**TOWN OF MOUNTAIN VILLAGE
REGULAR DESIGN REVIEW BOARD MEETING
THURSDAY JULY 11, 2019 10:00 AM
2nd FLOOR CONFERENCE ROOM, MOUNTAIN VILLAGE TOWN HALL
455 MOUNTAIN VILLAGE BLVD, MOUNTAIN VILLAGE, COLORADO
AGENDA**

AGENDA ITEM 5
PLANNING & DEVELOPMENT SERVICE
PLANNING DIVISION
455 Mountain Village Blvd.
Mountain Village, CO 81435
(970) 728-1392

Case Summary: The Town of Mountain Village, working with Tom Umbhau of Bauen Group, is requesting Design Review Board (DRB) Final Architectural and Site Review approval to construct two employee apartment buildings at 415 Mountain Village Blvd, Lot 1001R. The two additional buildings would provide a total of 49 new employee apartments and are proposed to be located adjacent to existing apartments within the Village Court Apartment Complex (VCA). In order to secure approval for this project as designed, the applicant is proposing a concurrent application process for Design Review, Density Transfer and Rezone for the creation of an additional 7 units of employee apartment density, and a Variance for the allowed Maximum Building Height. In order to provide clarity, staff will address the two new buildings in the same manner as the applicant and

PROJECT No. 20182606.00	ORIGIN DATE 11/13/2018
DRAWN BY JB	CHK BY TL TRV BY
SHEET No. H1.00	SCALE: 1/16" = 1'-0"

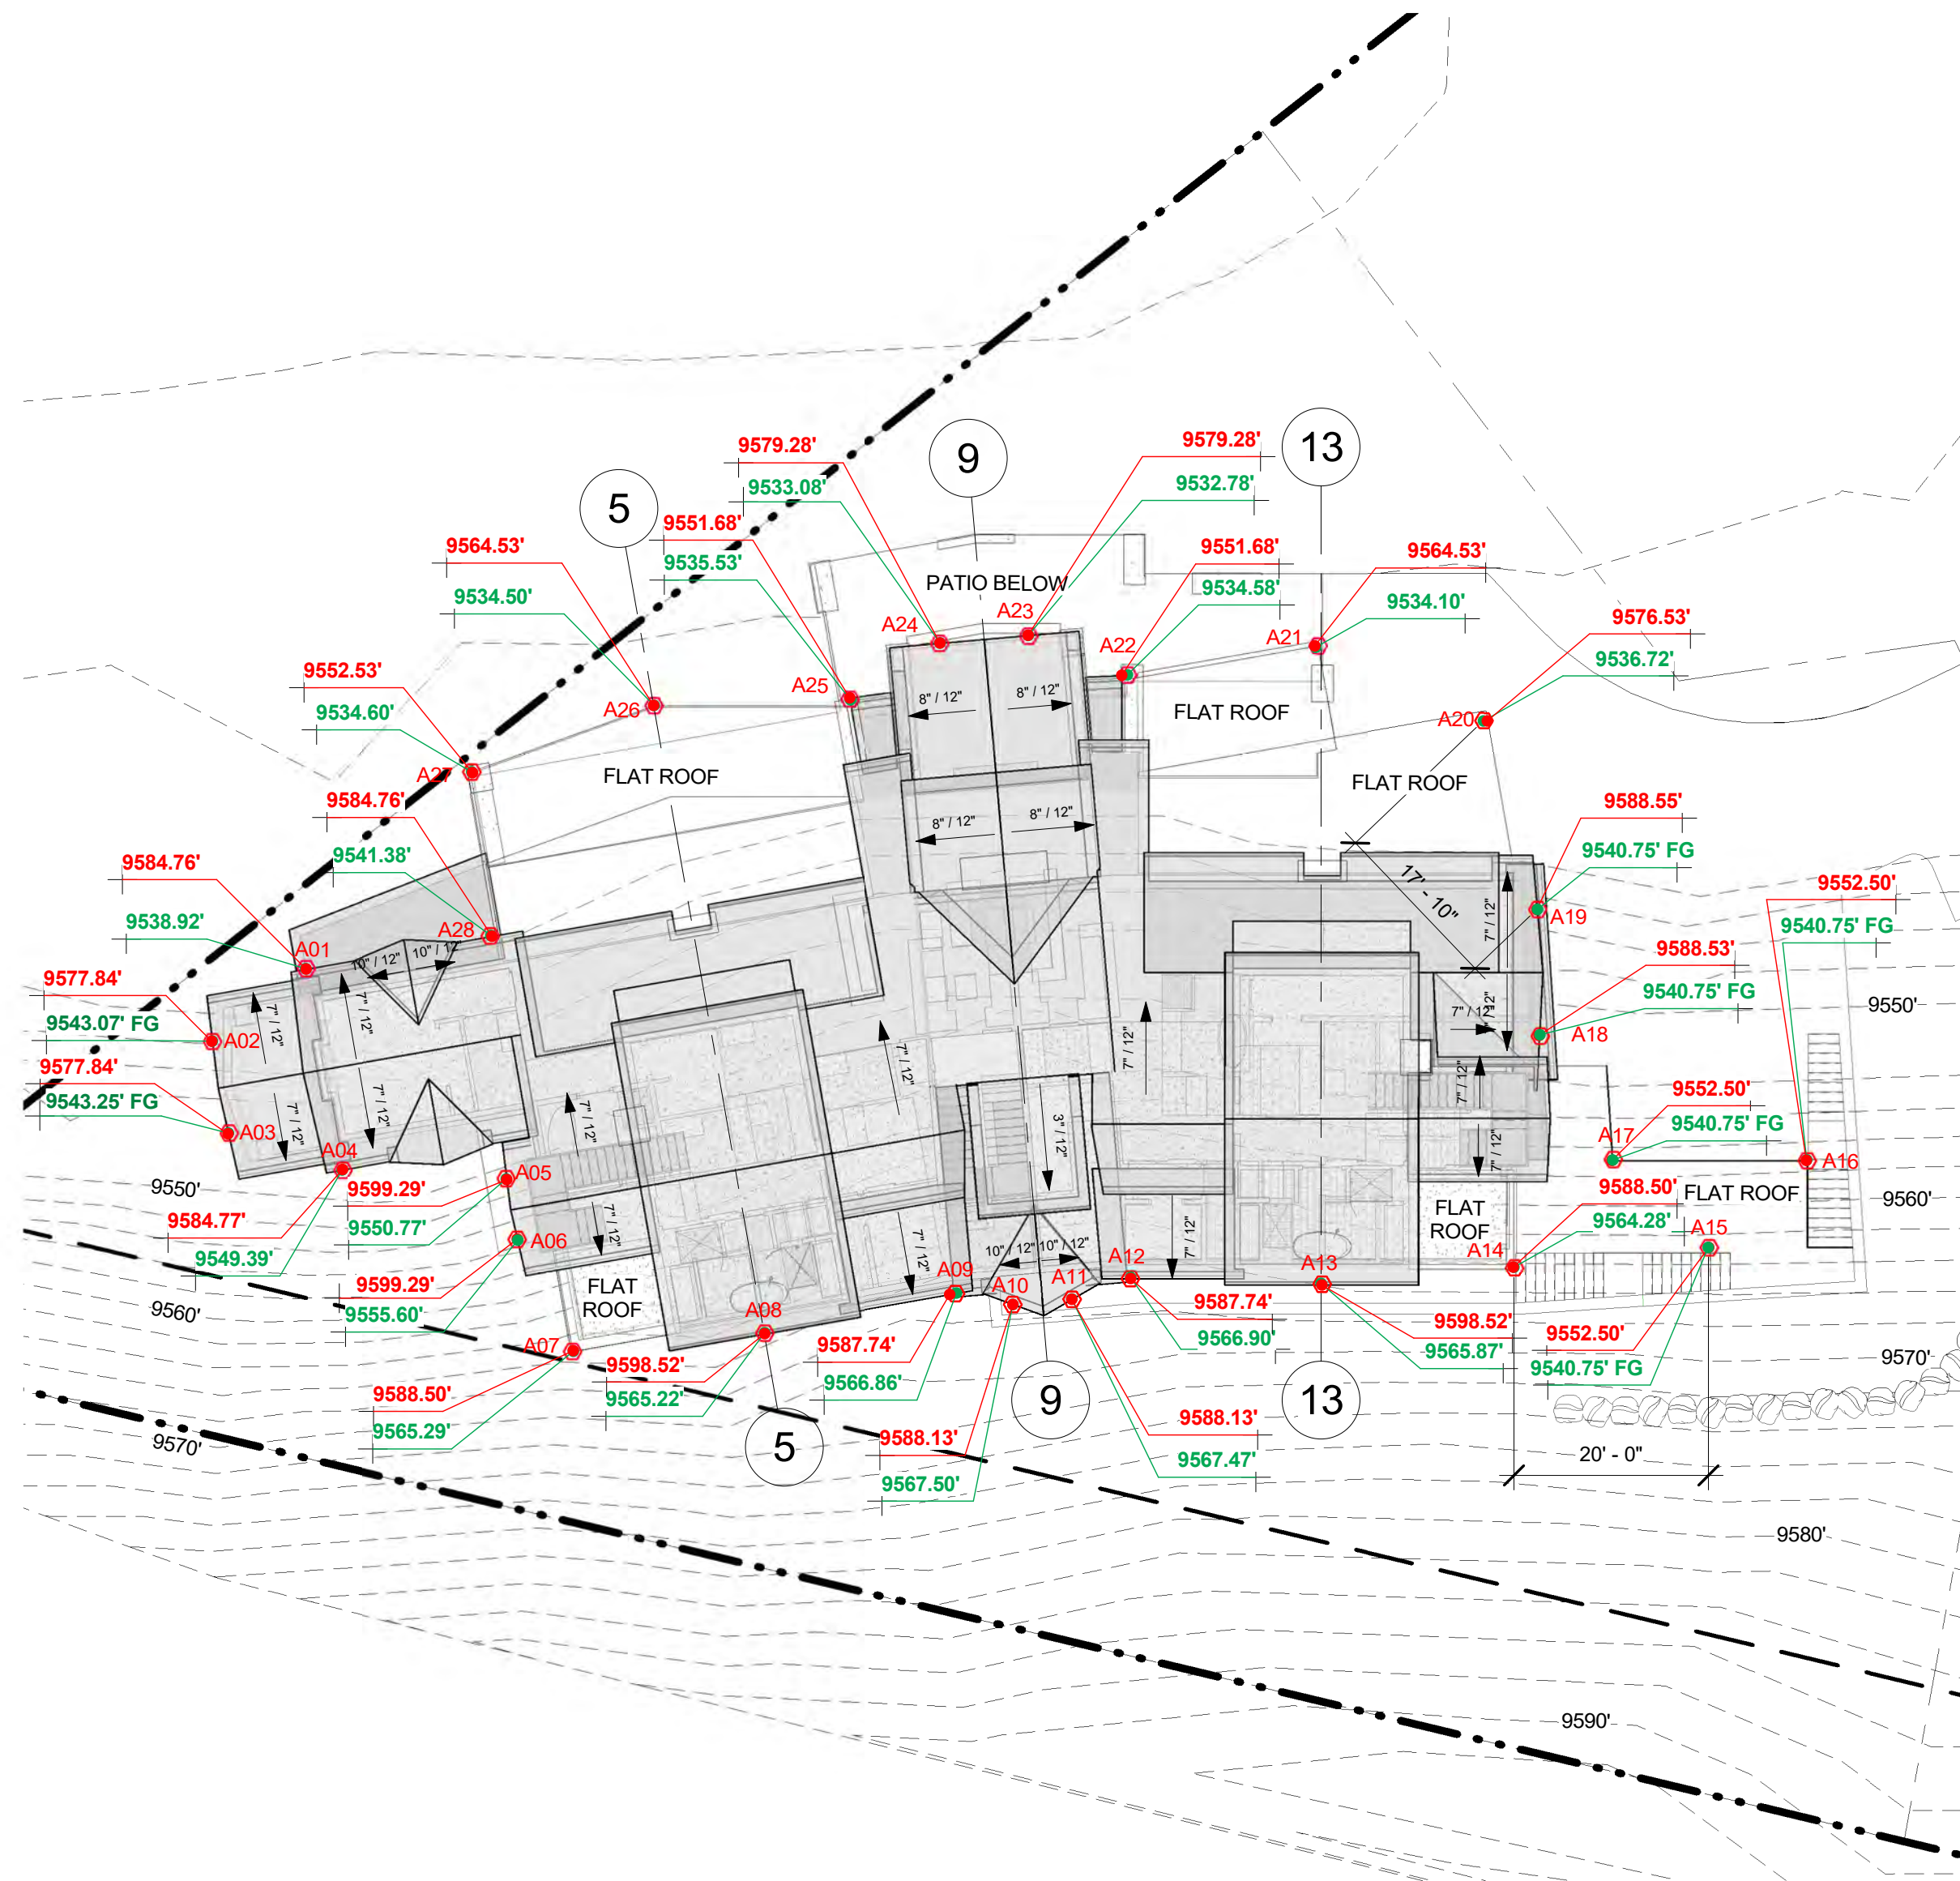
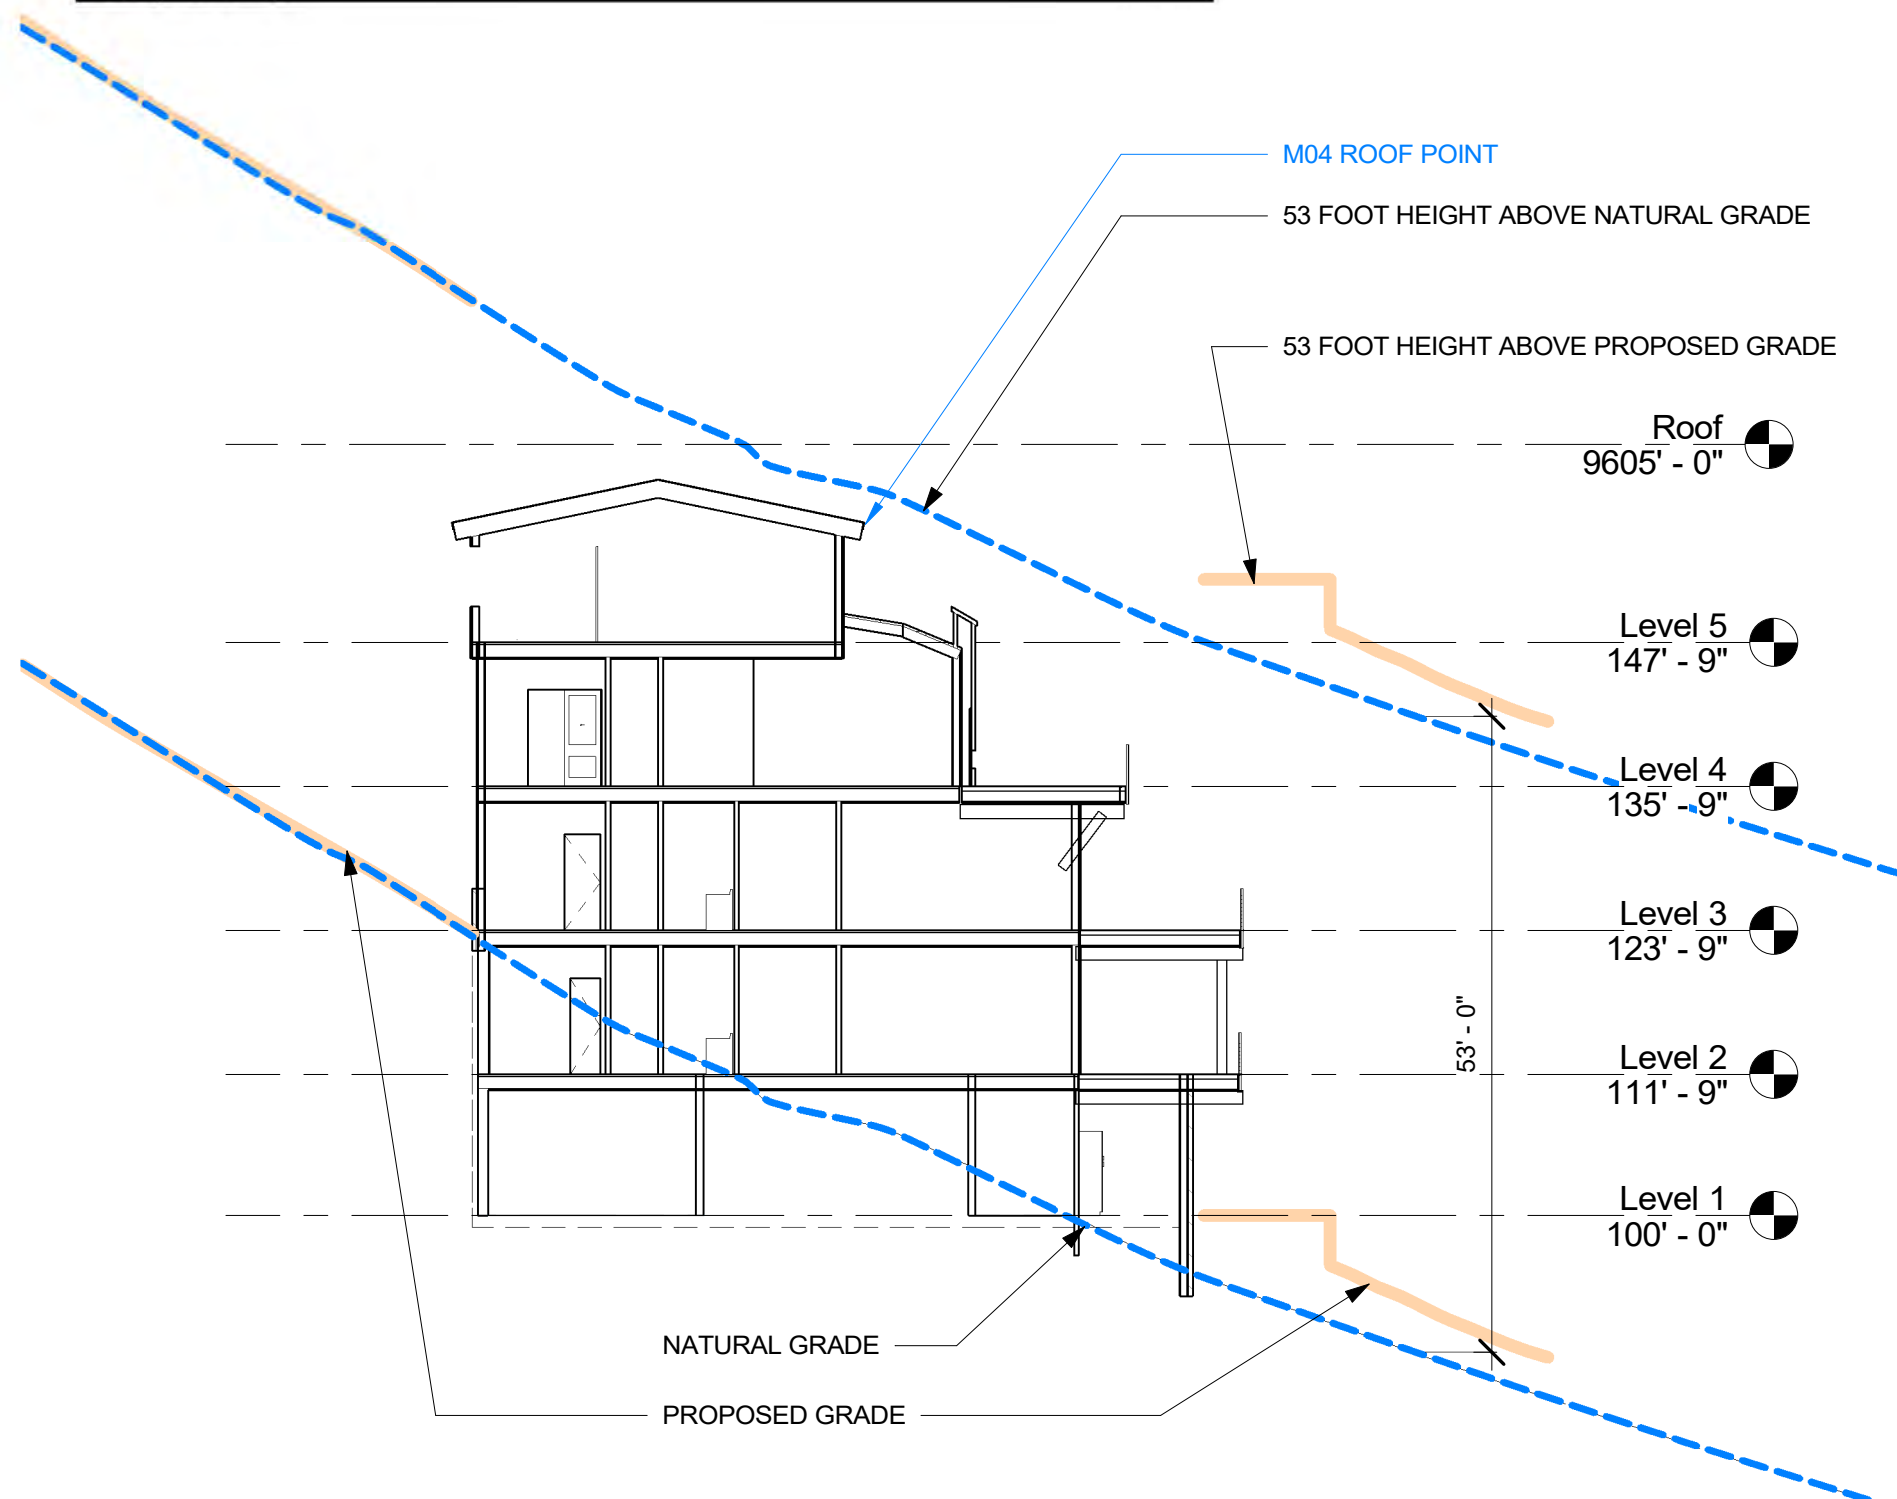
Staff: The applicant has provided a height analysis that demonstrates both Maximum Roof Height Calculations as well as Average Maximum Roof Height Calculations. According to page H1.00 of the plan set, the average height for the proposed designed is compliant at 34.60 feet and the highest point above the most restrictive grade is M08 which has a max height of 52.82 feet. The applicant has provided an average height analysis demonstrating all measurement points above the most restrictive grade, along with elevations demonstrating the height analysis showing a parallel slope analysis demonstrating
